Proposed Comments on STEC
Presentation focusing on CRR
Auction Revenues

CRR Revenue Offsetting Congestion Cost

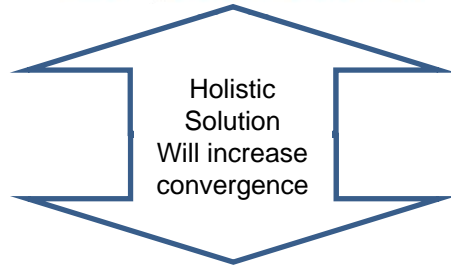
Question: Using STEC's
assumptions what percentage of
Congestion Cost would be offset
by CRR Revenue?

Note: CRR Revenues are
allocated on Load Ratio Share,
while Congestion is allocated
based upon Location.

When MP
have
confidence
in consistent
treatment of
congestion
then
Revenues
will Offset
Cost
